PLANNING COMMISSION
Regular Meeting
Monday, March 12, 2018
4:30 PM
Christine Nuernberg Hall

Agenda

TO: Planning Commission
FROM: JAC ZADER, ASSISTANT DIRECTOR COMMUNITY DEVELOPMENT
DATE: March 12, 2018
SUBJECT: Fox Tale Brewing Co., Inc. The applicant is seeking conditional use grant, building and site plan, sign waiver and certified survey map approval for a proposed brewery and restaurant located at 6411 W. Mequon Road.

1 ARCHITECTURAL SITE PLAN

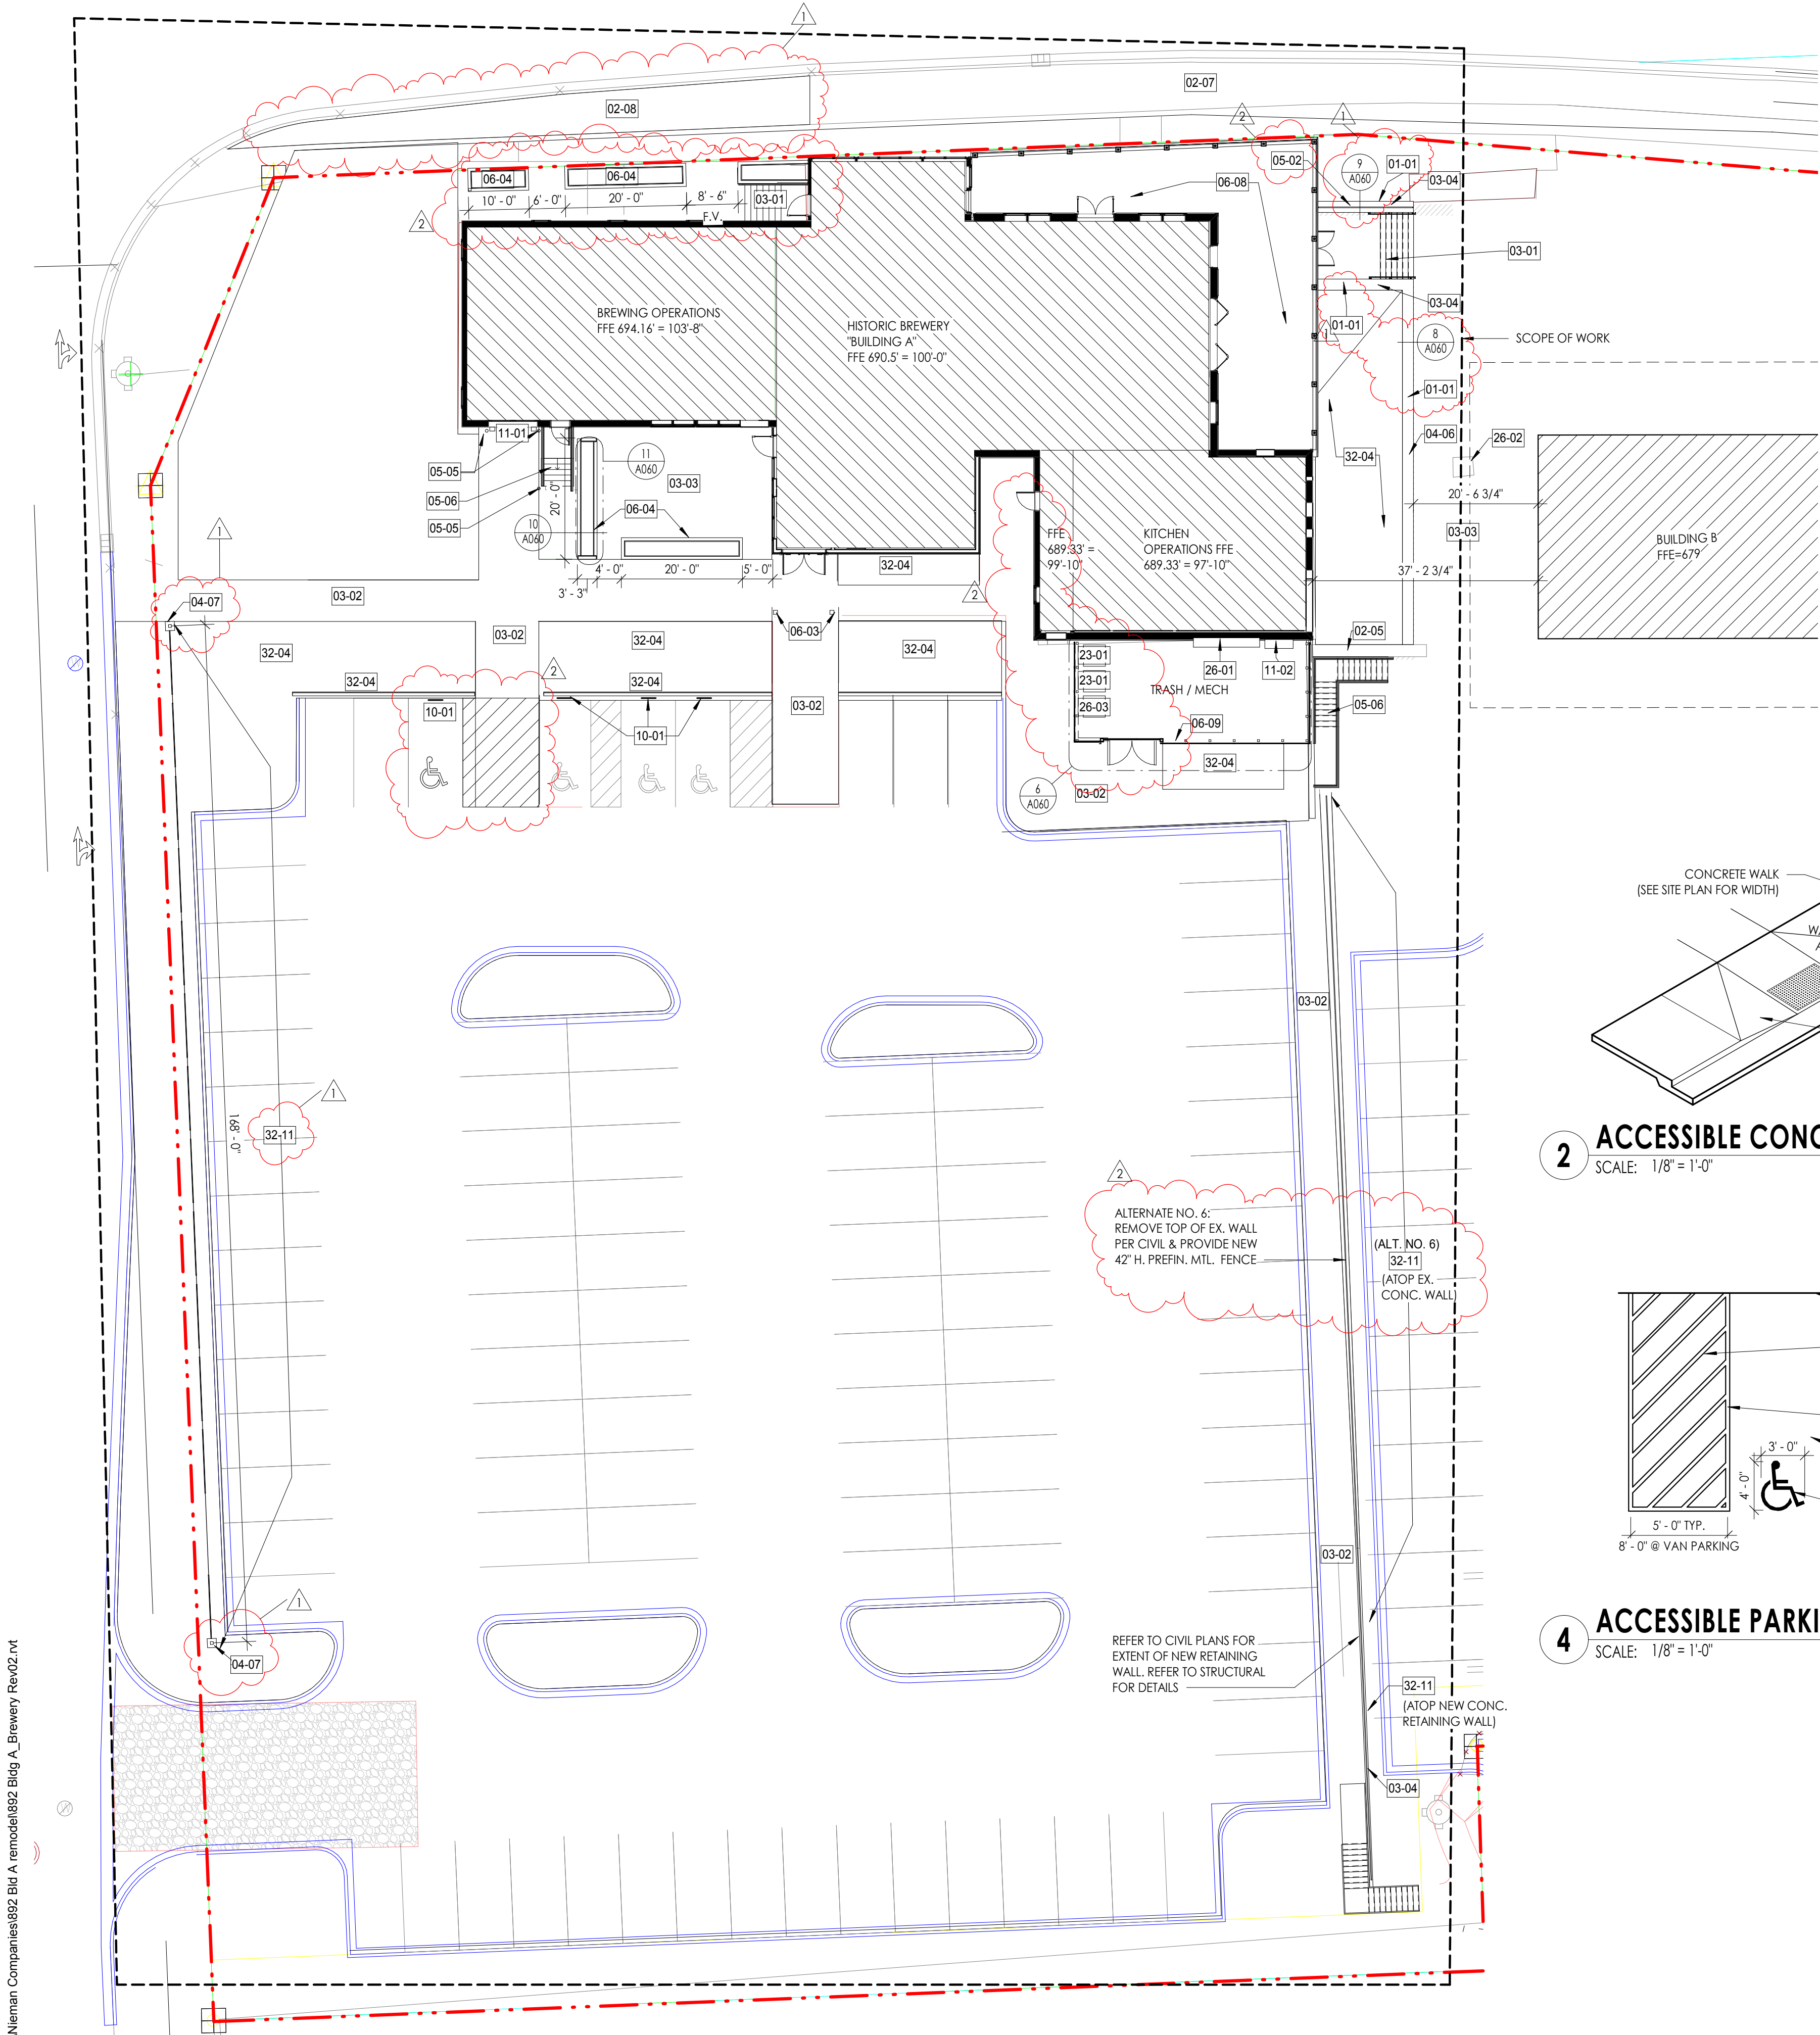
The proposed site plan shows a 6,100 square foot restaurant with an attached 1,700 square foot brewery located within the existing building. The building layout and parking lot is similar to what was shown on the approved concept plan. The building will include brewing operations, a public beer hall with outdoor seating area and is expected to be open in late 2018. The overall parcel is 2.4 acres in size. The applicant has submitted a draft CSM that shows the parcel being split into two parcels with the restaurant being located on Lot 1 which is 1.3 acres in size. The frontage percentage along Mequon Road is approximately 71% based on the draft CSM for Lot 1 which complies with the zoning code. As identified at the time of concept plan approval, the proposed plan does not comply with the 70% building frontage requirement along Buntrock Avenue. In accordance with the PUD approval, the applicant has added fencing along Buntrock Road to reduce the visual impact of the parking area and enliven the streetscape. The parking lot offset along Buntrock Avenue is shown at five feet which doesn't comply with the ten foot offset required by the code. The reduced offset is necessary to allow for the additional row of parking on the site in order to meet the code required number of stalls. Staff is supportive of the waiver.

The plan shows a total of 100 parking spaces dedicated on site which is in compliance with the zoning code based on the proposed uses at this time. As part of the rezoning process, the applicant was required to complete a parking and traffic analysis. The report was completed by TADi on November 29, 2017. The analysis shows that traffic demand generated by the proposed uses can be met during all times with the exception of summer time during dinner hours. Since the building will be completed in winter additional parking will not be needed until summer of 2019. The applicant states that parking lot and access point to adjacent parcel will be completed prior to summer of 2019 (See concept plan sites B and C). Staff will require shared vehicular and pedestrian access with parcel B and C as well as with Spectrum Investments be completed by May 1, 2019.

4 NORTH ELEVATION
SCALE: 1/8" = 1'-0"

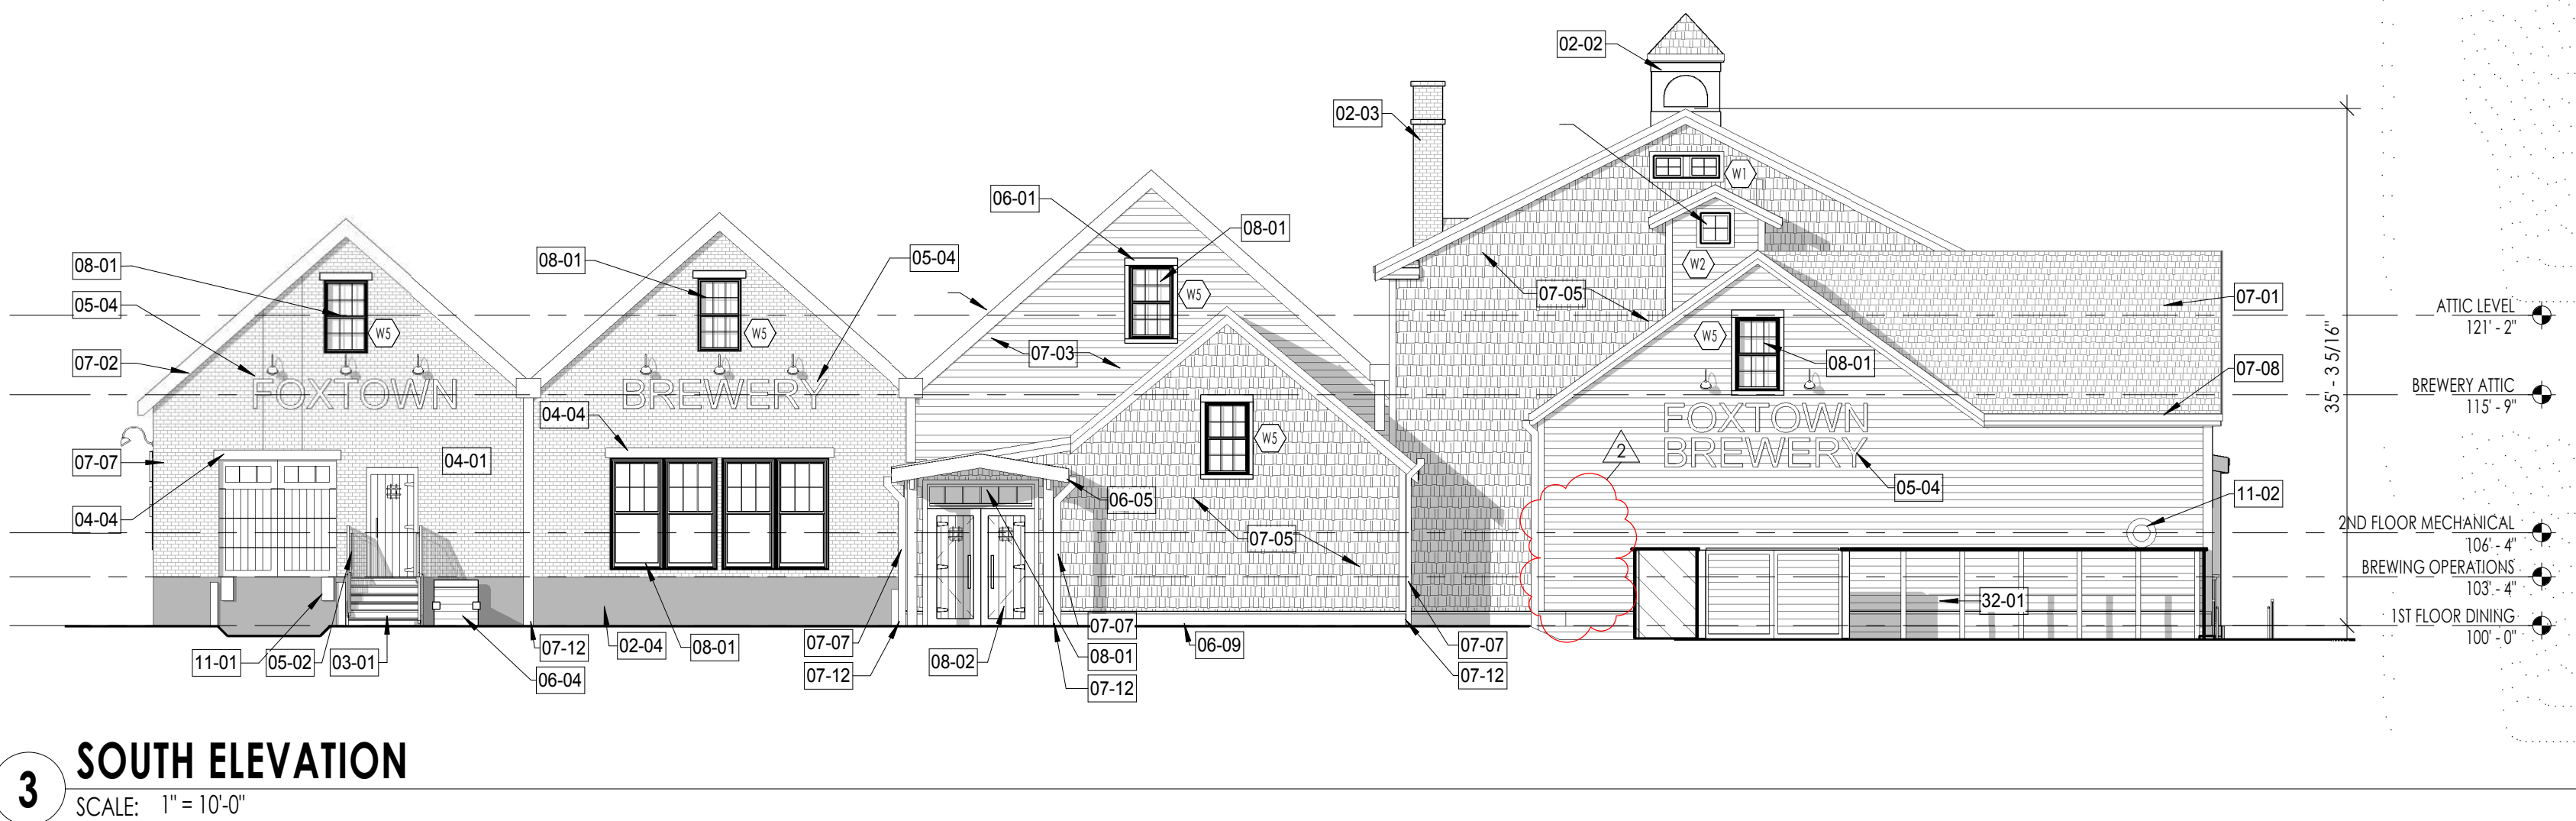
While the primary entrance to the restaurant is located on the south façade of the building, the code states that each principal use shall have at least one entrance clearly defined with architectural features facing the public street. While the has applicant has added planters and an

7. Planning Commission and Common Council approval of a development agreement for all improvements in the public right of way.
8. The entrance on the north elevation shall include additional design elements to promote the entranceway.

4 ROOF SIGNAGE - 4 @ EAST FACADE
SCALE 1/4" = 1'-0"

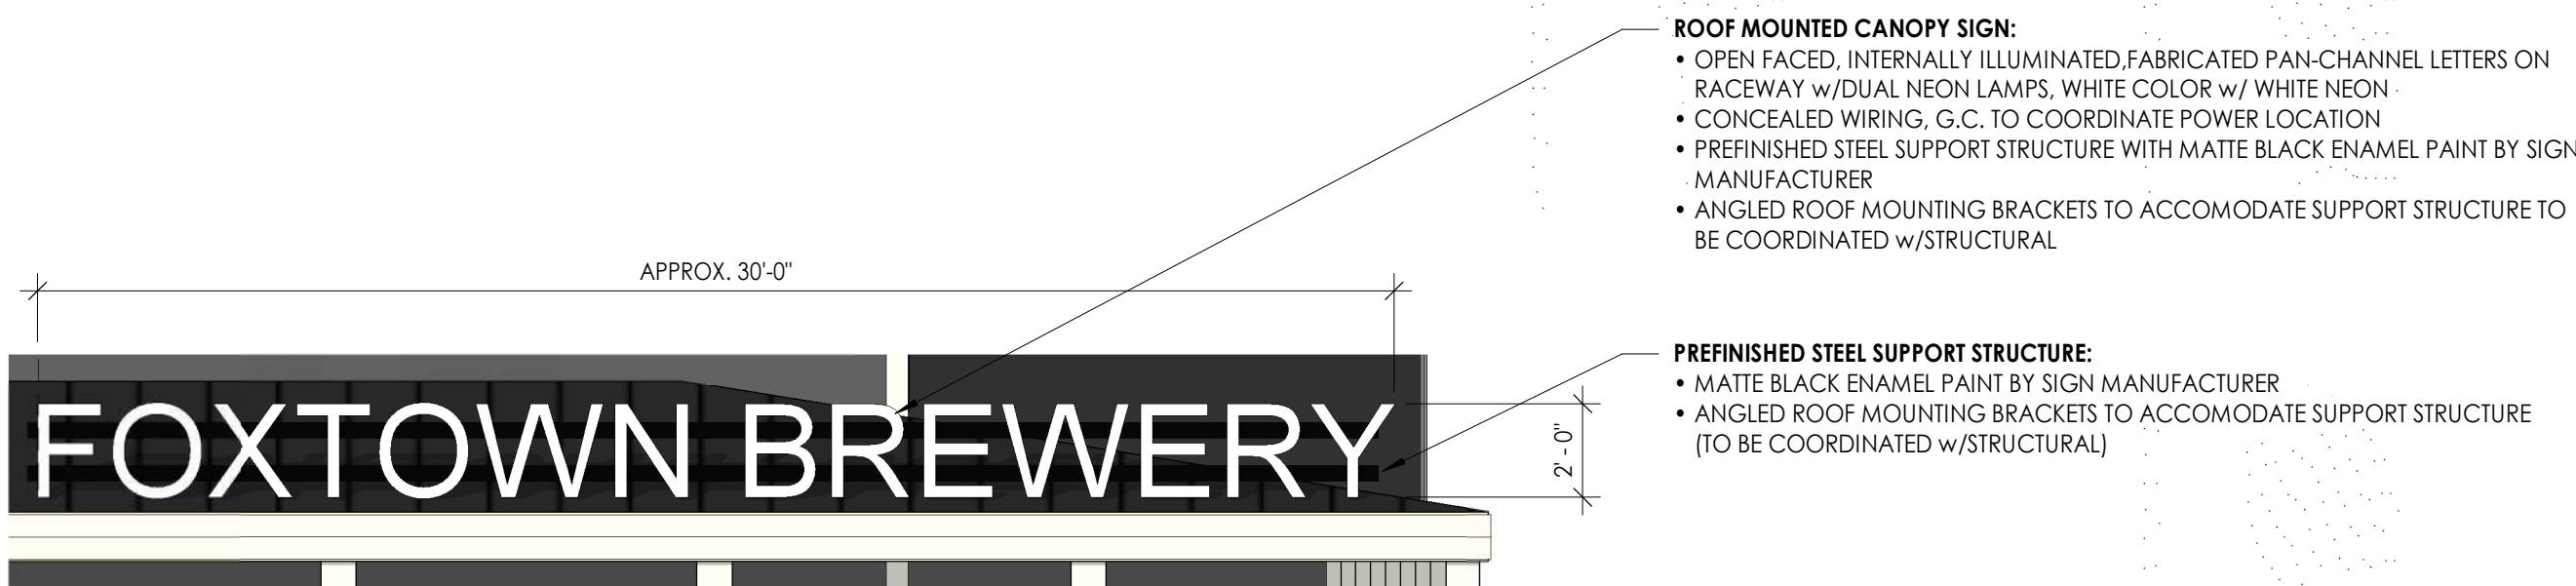
The applicant is requesting approval for four wall signs ranging from 56-60 square feet in area. Waivers are required for the number of signs, the size of the signs and the location of one of the signs on the roof of the building. Since the building is on a corner, two signs are permitted for the development. The proposed plan shows two signs on the south elevation and one on the east and west elevation. Since there is no signage proposed on the north elevation, staff is supportive of the signs on the east and west elevation in order to capture both eastbound and westbound traffic. Staff does not support two signs on the south elevation and would recommend the sign on the easternmost portion of the building be removed.
